SUBJECT: Transmittal of Revised Responses to AP1000 DSER Open Items

**AP1000 Design Certification Review
Draft Safety Evaluation Report Open Item Non-Proprietary Responses**

DSER Open Item Number: 19.1.10.1-5 (Response Revision 1)

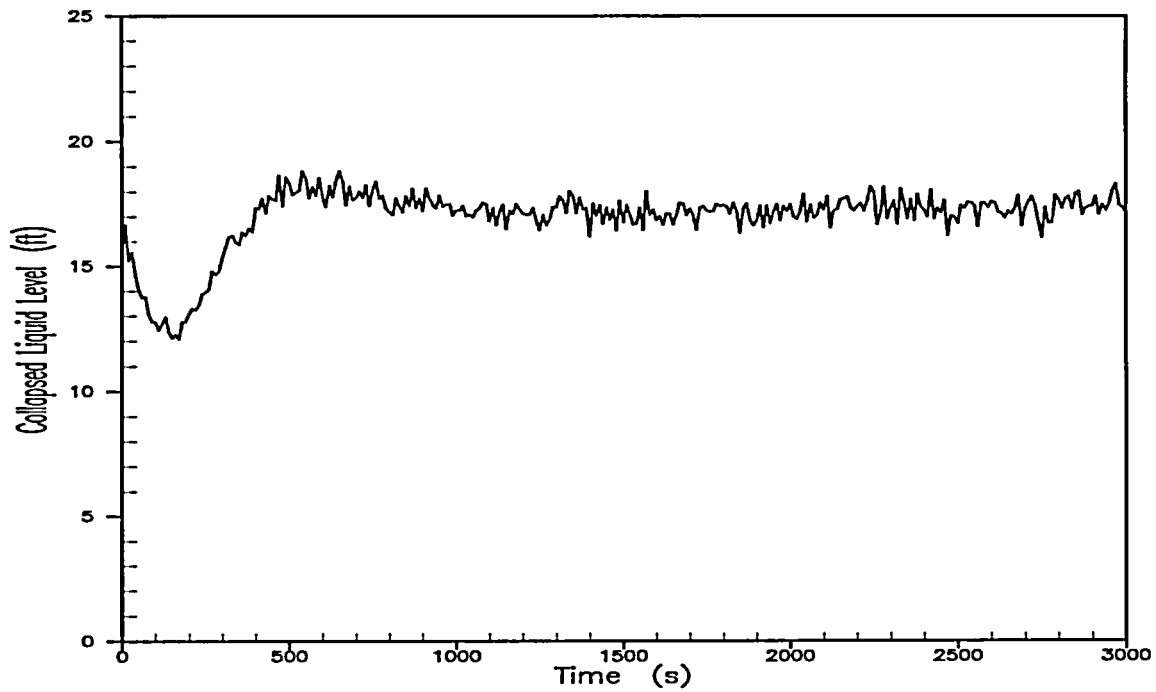
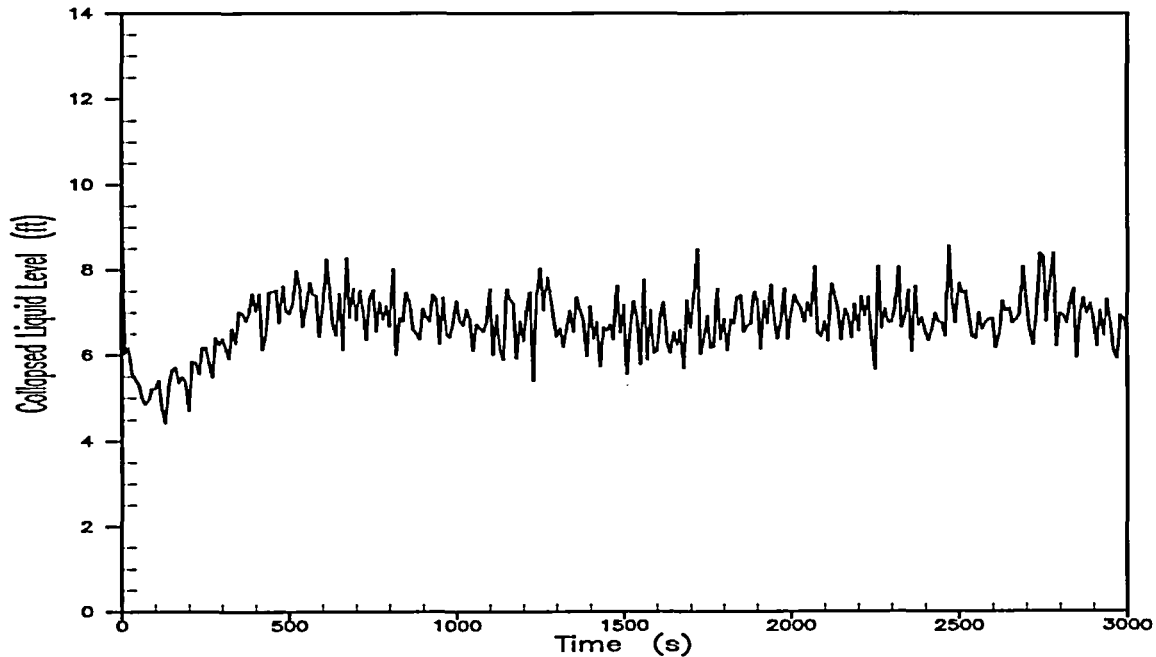
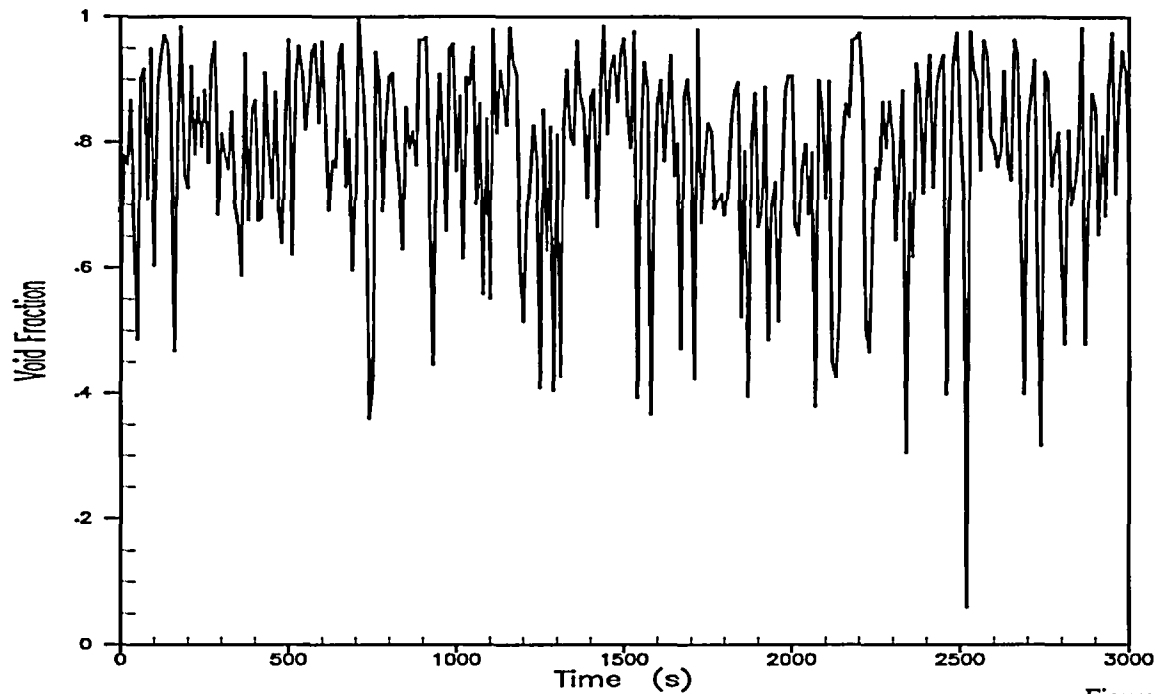
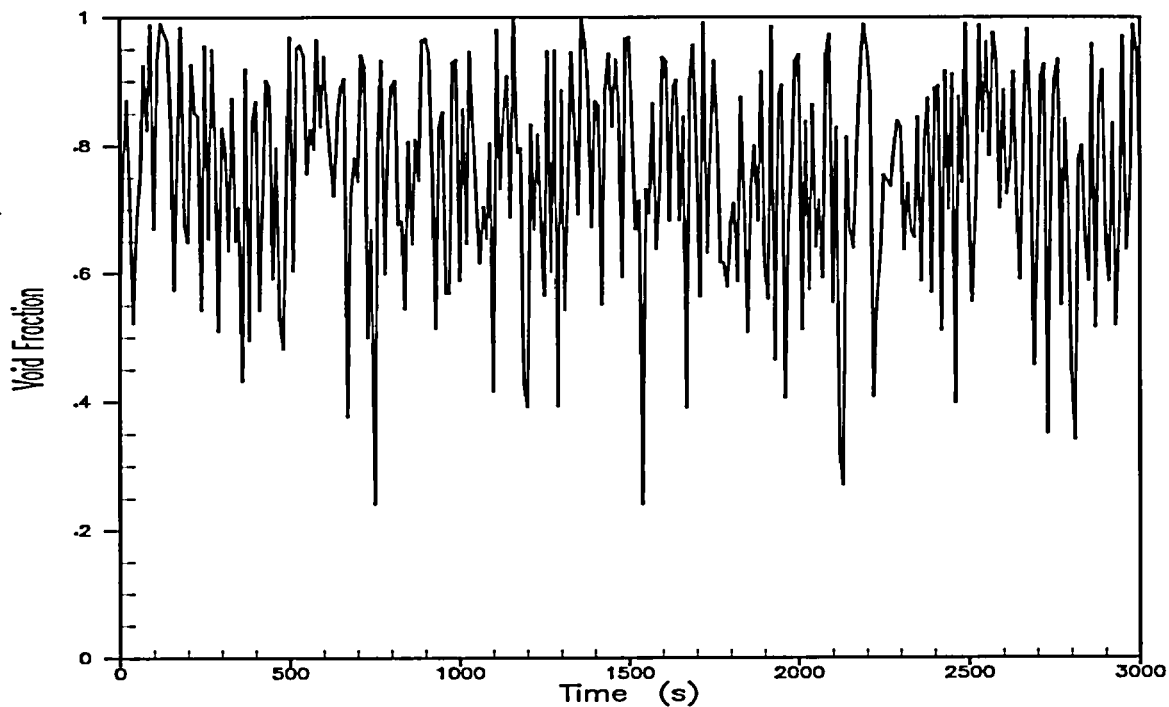
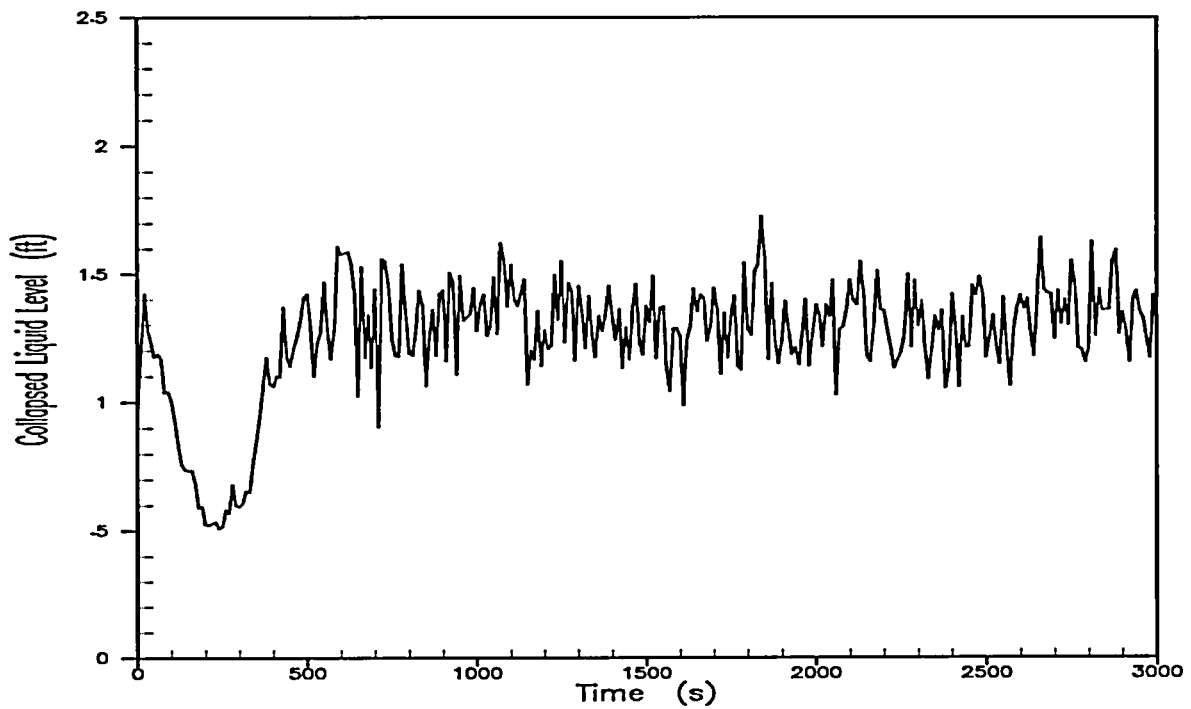
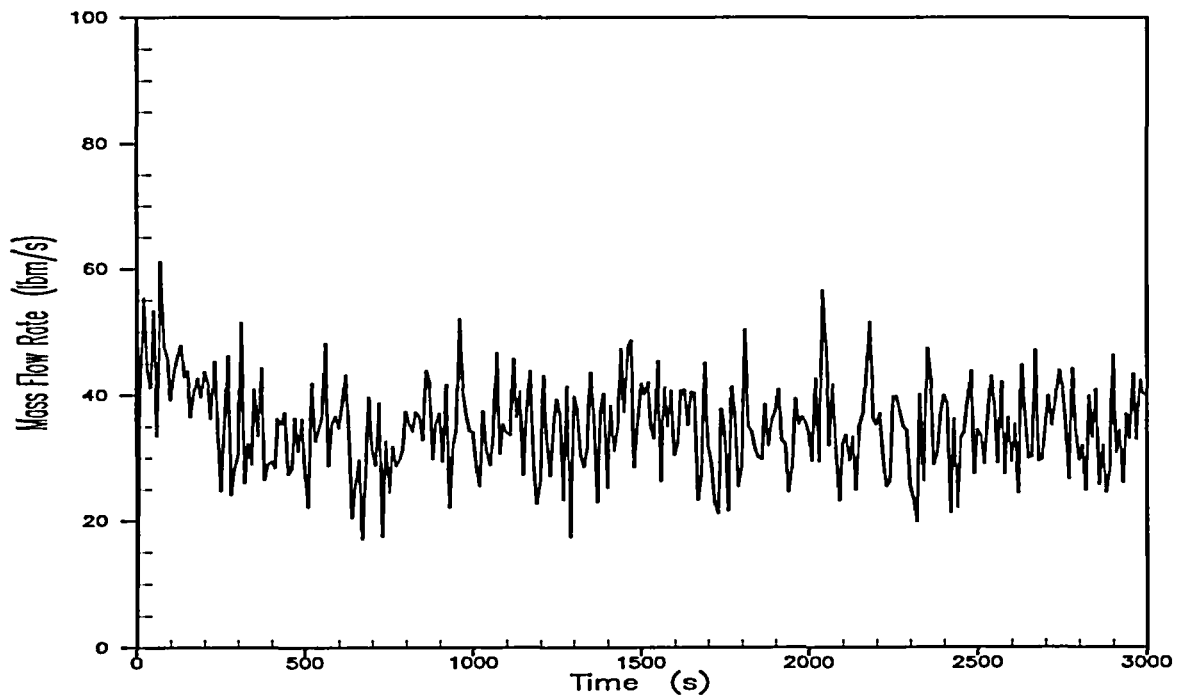
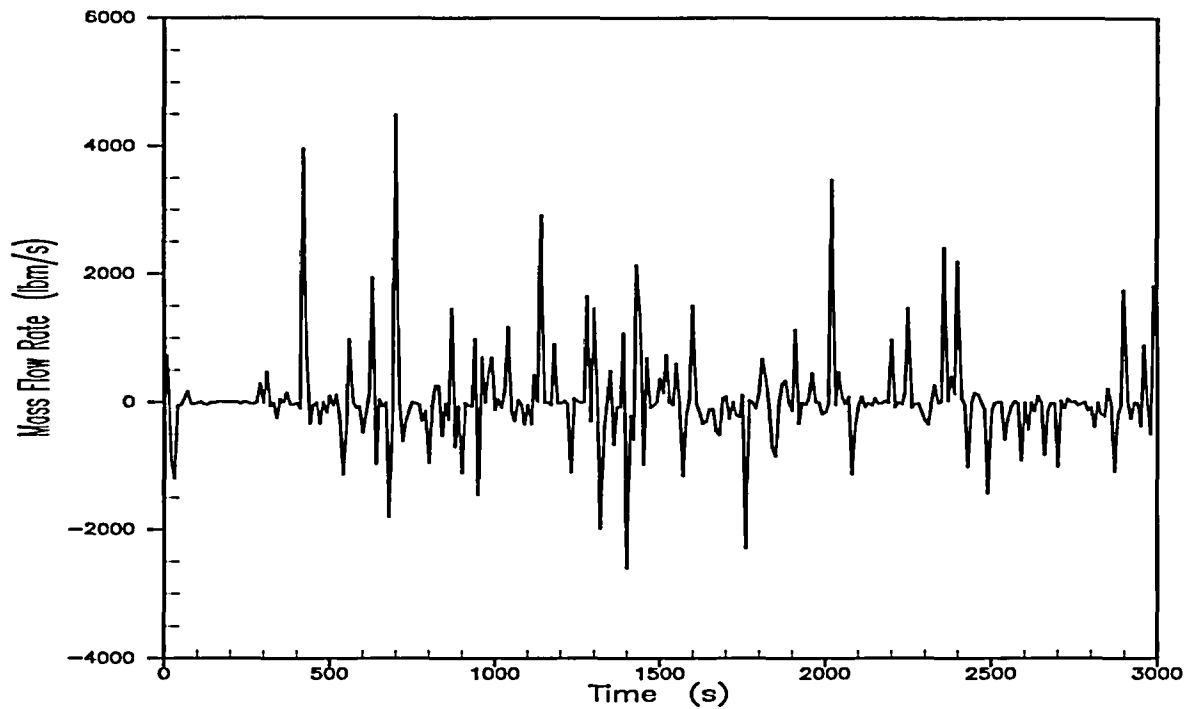
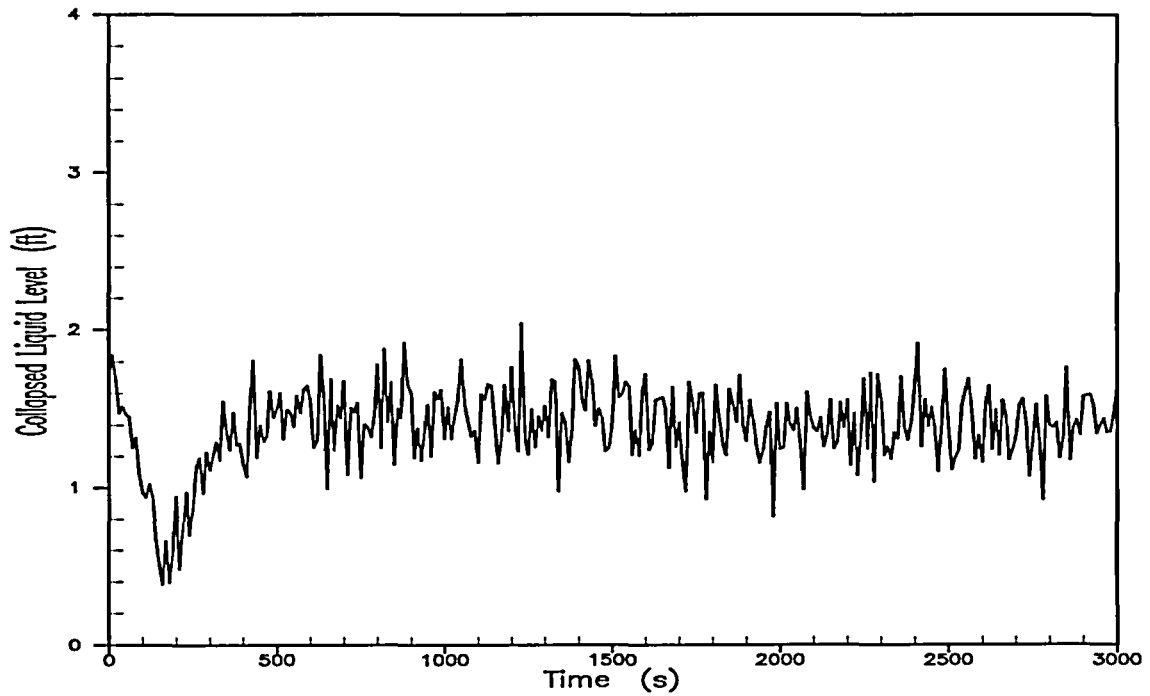
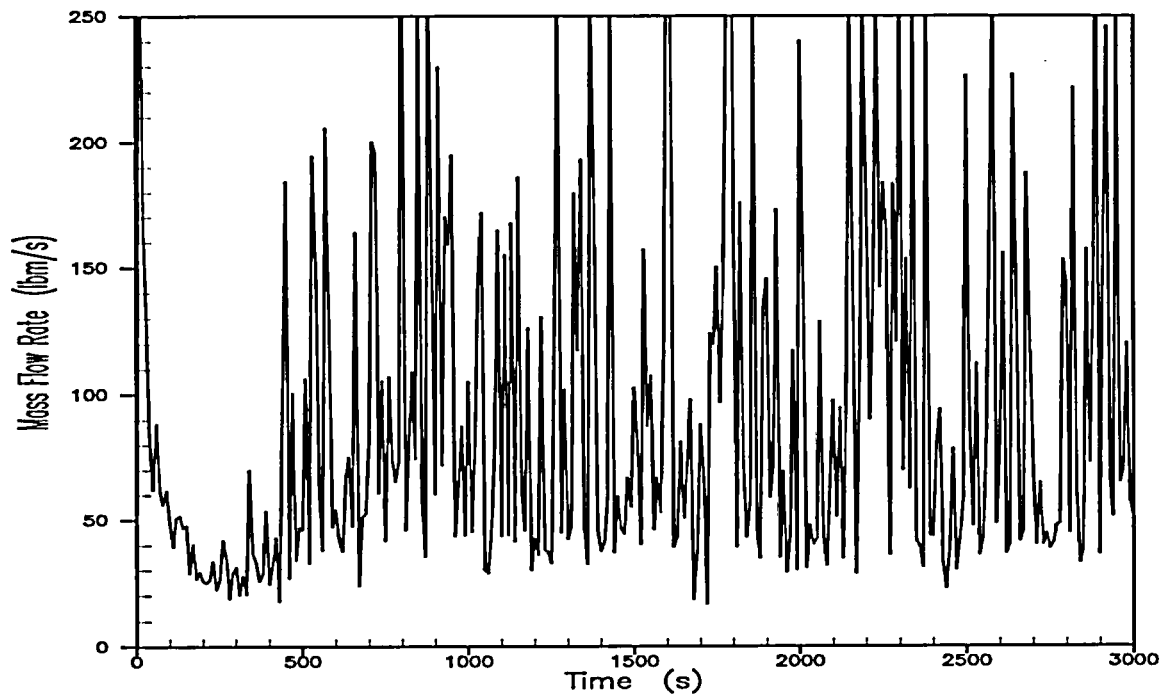
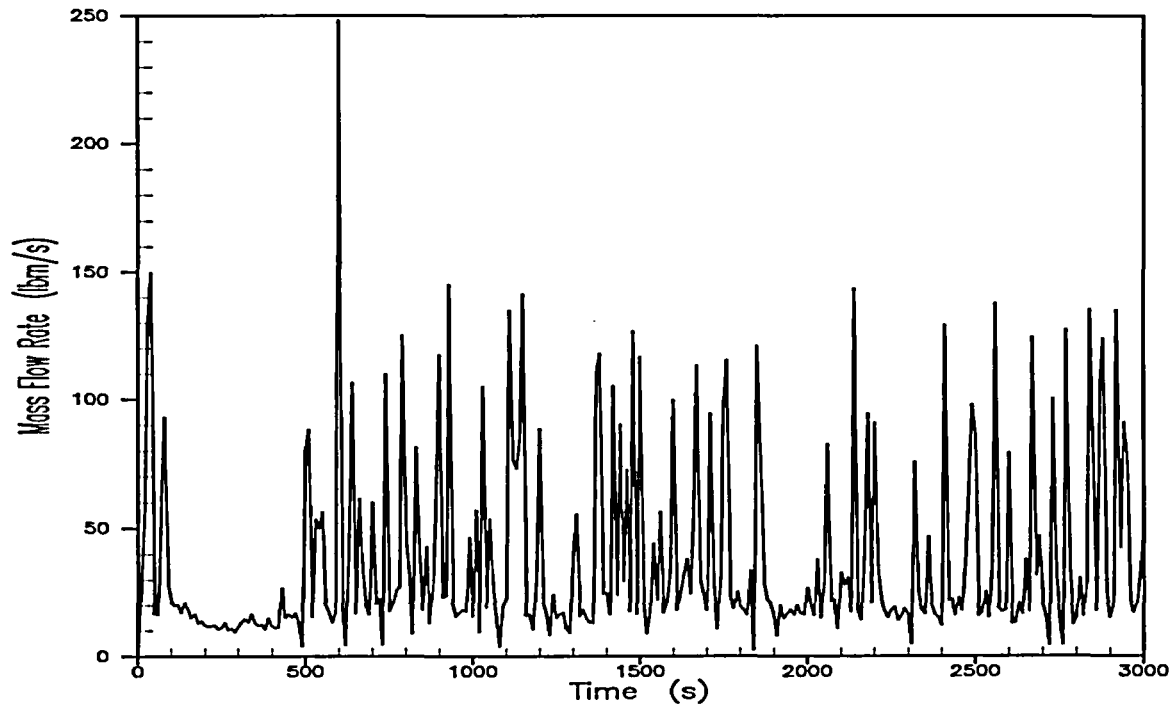
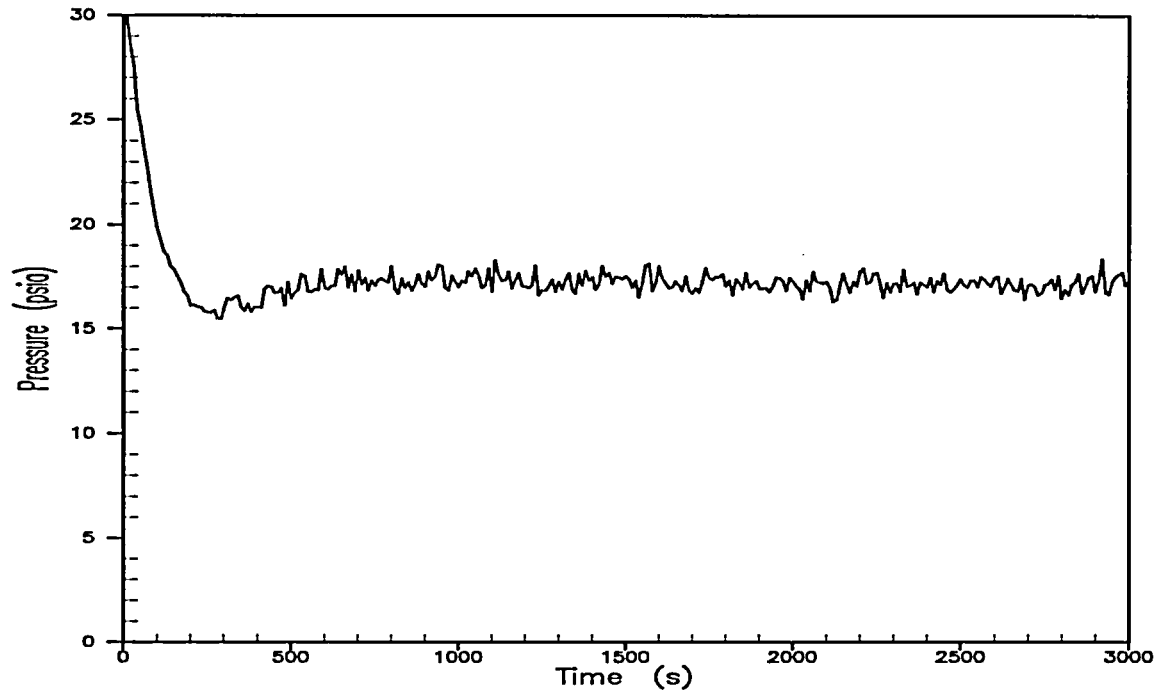
- (f) Additional justification should be provided that sequences which assume failure of one of the four ADS stage #4 valves and also assume failure of containment isolation, will end in successful core cooling (RAIs 720.012, 720.009 and 720.017):

This issue is unresolved. In the revised response to RAI 720.09, Westinghouse presented the results of an analysis using WCOBRA/TRAC with inputs determined from a MAAP4 analysis. The staff has the same issue with this analysis as is stated under Item a. In the revised response to RAI 720.17, Westinghouse argued that this case is not risk significant and therefore it is not necessary to perform a T&H uncertainty analysis. This argument is not valid since OK6 (See Figure 2-4 of RAI 720.012), OK2 and OK4 sequences (on Figure 2-5 of RAI 720.012) fall in this category. Are these OK sequences considered to be low risk?

- (f) The long term cooling success criteria analysis in the revised response to RAI 720.09 (3 of 4 ADS4, containment isolation failure) has now been performed using the revised WCOBRA/TRAC model and using input conditions from WGOTHIC. The revised analysis replaces the previous one as shown below in the revision to PRA Appendix A. This confirms the success criteria for this case. With respect to the statement we made in RAI 720.017 rev 1 about a T&H uncertainty case with 3 ADS-4 valves and failure of containment isolation, we have the following response. Such a sequence is not risk important with the current expanded event trees. The question regarding sequences that we identified as OK sequences with 3 ADS-4 valves and CI failure is a new / different question. These sequences are less severe than the success criteria case in that they have some ADS 2/3 valves opening and have 1 CMT (in addition to 1 Accumulator). The addition of the CMT will compensate for the water lost out of the containment through a failed CI. In addition, these OK sequences have probabilities of ~ E-10 / yr, or less. The highest UC sequence with 3 ADS-4 and failed CI is UC8/sad27, see PRA Appendix A Table A5.1-2. This sequence has a CDF probability of 2 E-10 and is not risk important.

into the downcomer through the DVI break supplements the IRWST injection. As this flow path becomes established, the levels in the downcomer (Figure A3.5-1), the reactor core (Figure A3.5-2), and the upper plenum (Figure A3.5-8) are sufficient to maintain core cooling. The effect of this injection flow increase is also seen in Figures A3.5-3 and A3.5-4, which show a void fraction decrease in the upper half of the core.

The three available ADS Stage 4 valves provide enough venting capacity that adequate depressurization capability exists to achieve successful performance of the passive safety systems (Figures A3.5-9 and A3.5-10). The fuel remains covered throughout the transient, and adequate core cooling is provided to remove the decay heat. The hot rod cladding temperature at the top of the core is slightly above saturation temperature (Figure A3.5-12) throughout the transient.
